ADDENDUM #1

REQUEST FOR QUOTATIONS (RFQ) NO.: 1220-040-2018-066

TITLE: CATHODIC PROTECTION SURVEY

AND MAINTENANCE

DRAWINGS TO ANSWER 4, FOR REFERENCE PURPOSES ONLY

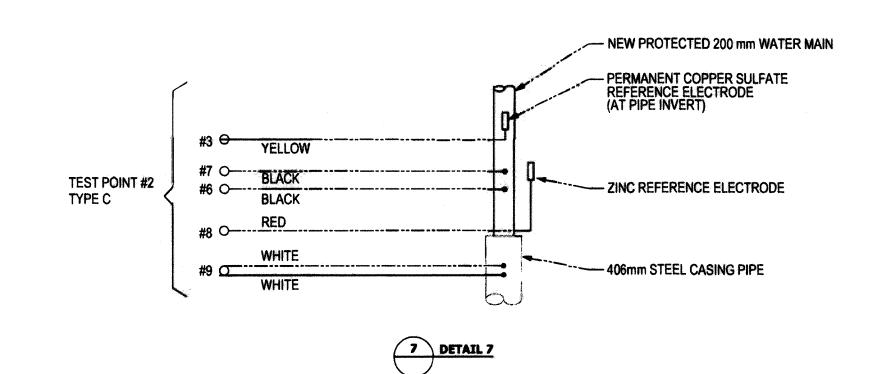
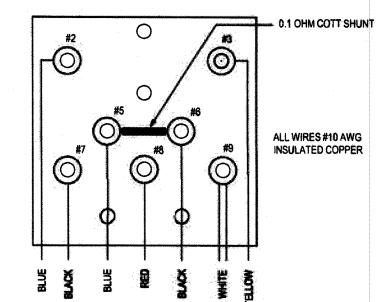
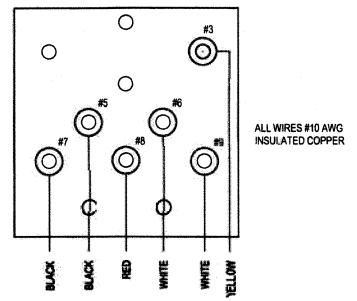
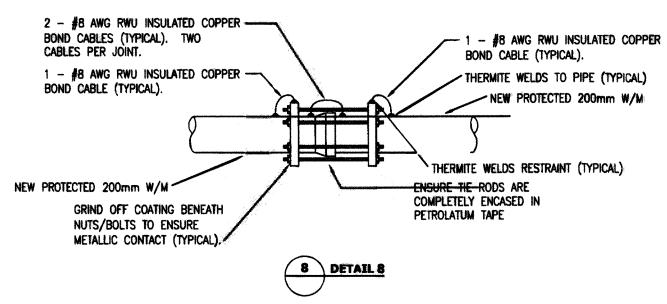
- Q4: Would it be possible to see a picture, or drawing of a typical test station, inside and out?
- A4: The City does not have pictures but Contractors can search drawings in COSMOS. Attached are three (3) drawings for reference only.

AS-BUILT DRAWING TO ANSWER 7, FOR REFERENCE PURPOSES ONLY

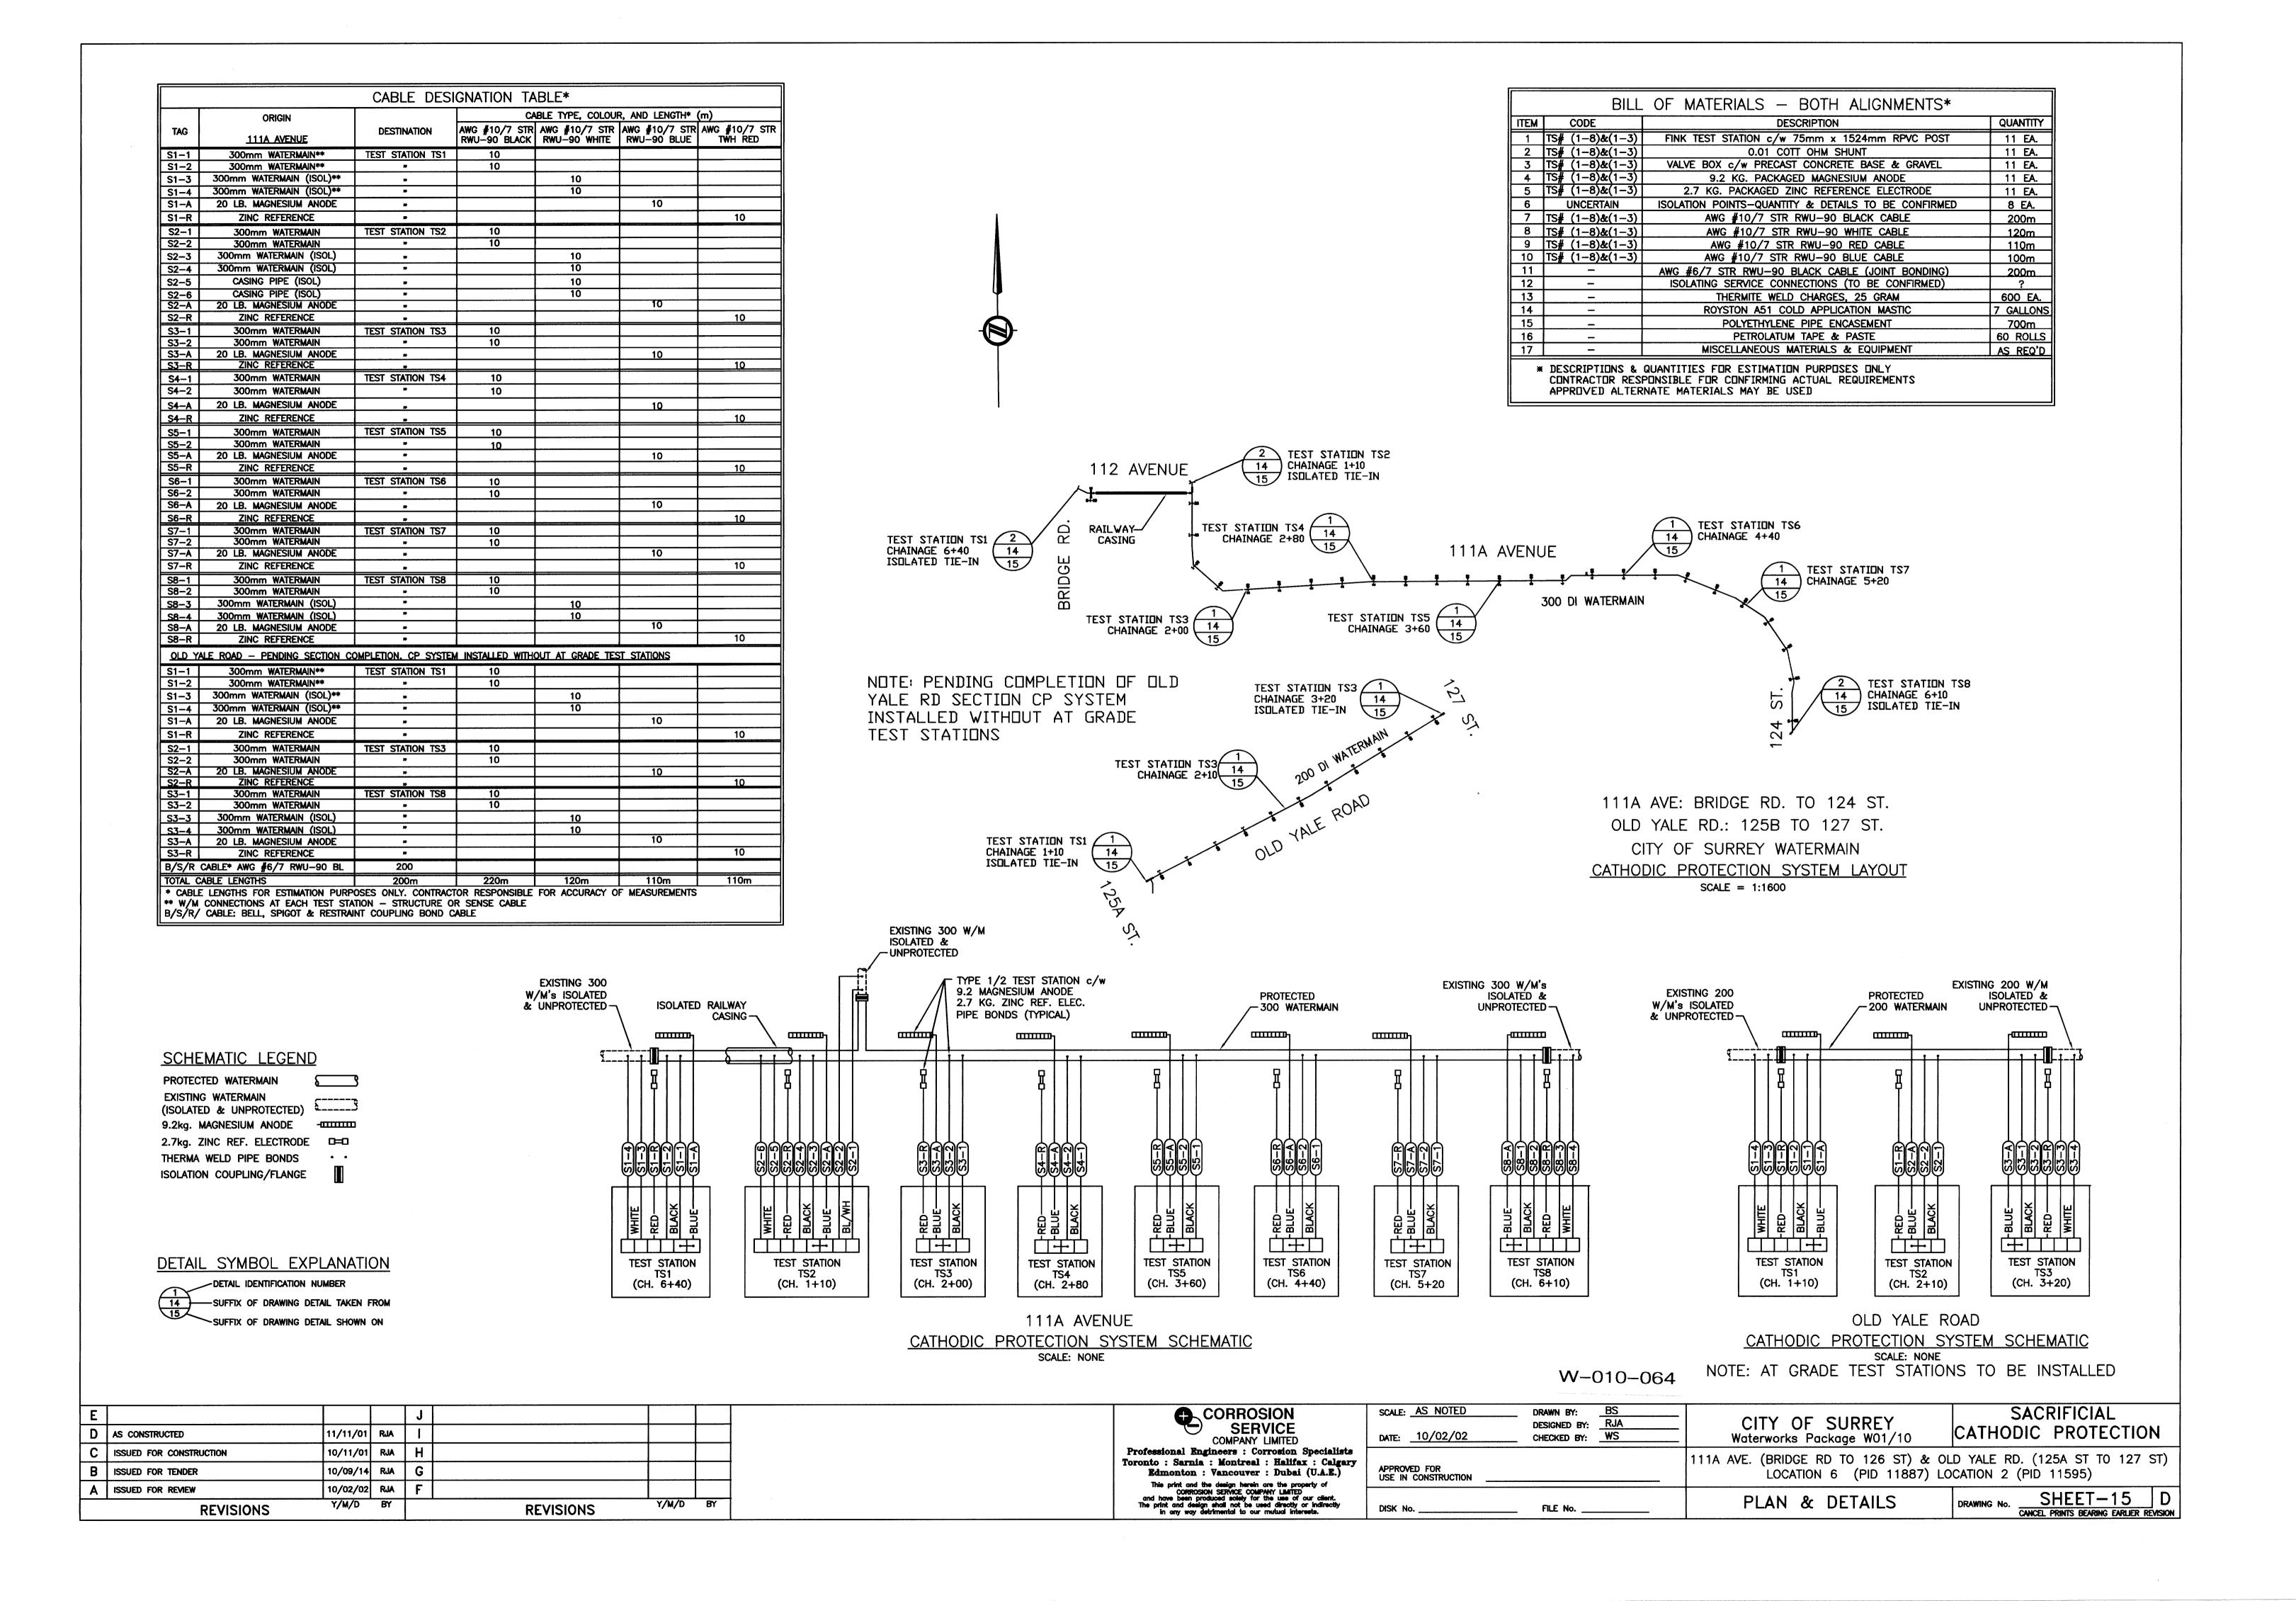
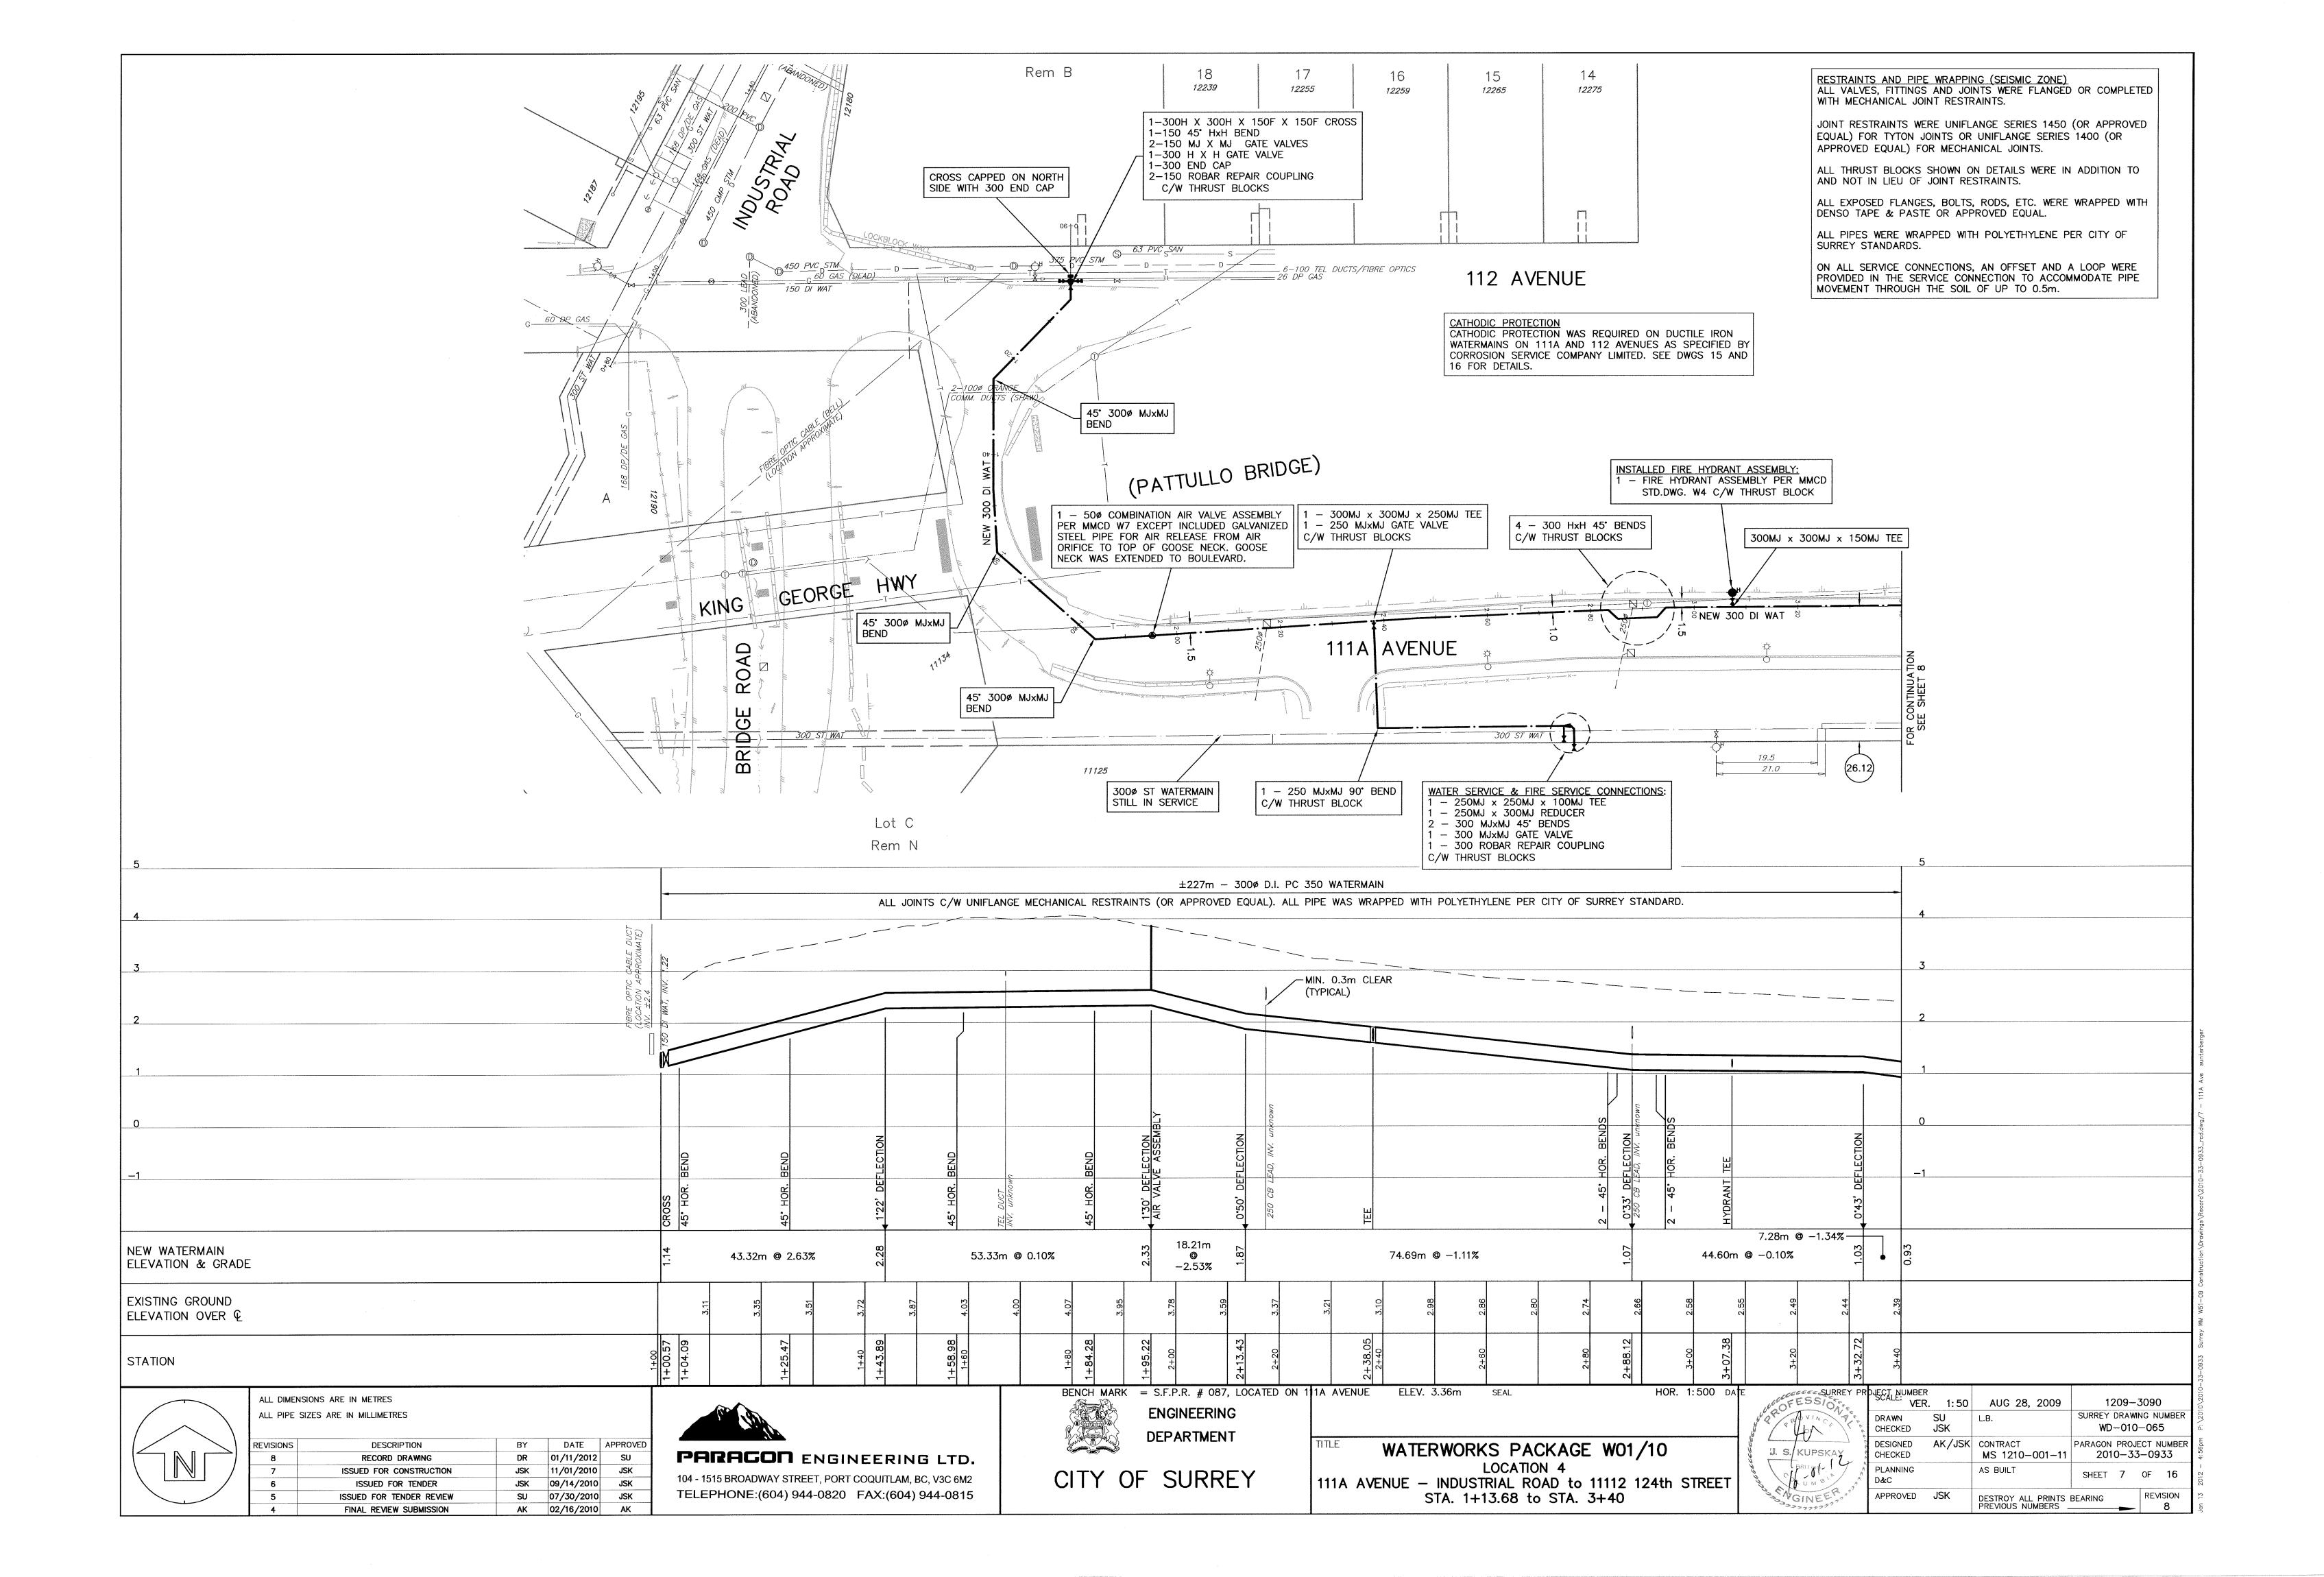
- Q7: Would it be possible to see one typical as built drawing of any of the 27 CP systems in order to better understand the type of CP systems we will be inspecting?

- A7: Contractors can search for as-built drawings in COSMOS. Attached is one (1) drawing for reference only.
- Q8: Will manhole entry/confined space ever be necessary to reach a certain test station or cable connection?
